Response to Submissions Report

Sancrox Quarry Expansion (SSD 7293)
Sancrox Road, Sancrox

Submitted to Department of Planning, Industry &
Environment

20 May 2021 | 2190085

Figure 5 Future Urban Investigation Areas

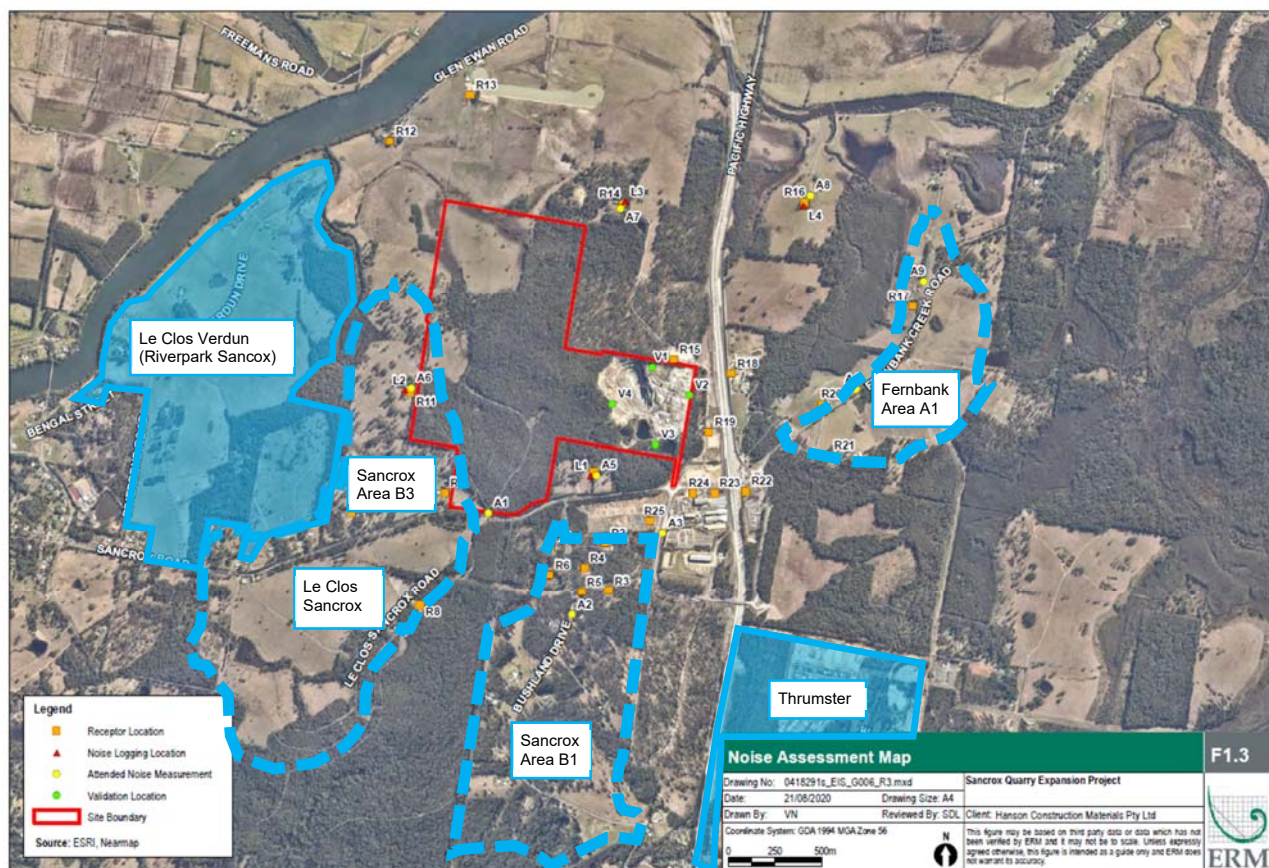
- *The draft Fernbank Creek and Sancrox Villages Structure Plan and Le Clos Sancrox Planning Proposal should be considered in the assessment of the Sancrox Quarry Expansion Project as applicable*

A summary of the proposed and approved residential areas surrounding the site is provided below, and illustrated in **Figure 3** (which overlays the proposed and approved residential areas over the sensitive receptors map from the revised Nosie and Vibration Assessment Report at **Appendix E**):

Further as documented in Section 1.8.4 above, neither the North Coast Regional Plan 2036 nor the Port Macquarie Draft Regional City Action Plan, identify the land around the Sancrox Quarry as being an Investigation Area for Urban Land, and the North Coast Regional Plan 2036 provides a framework for considering variations of the Urban Growth Area which requires the proposed new urban area to address the potential for land use conflict by being appropriately separated from incompatible land uses, productive resource lands.
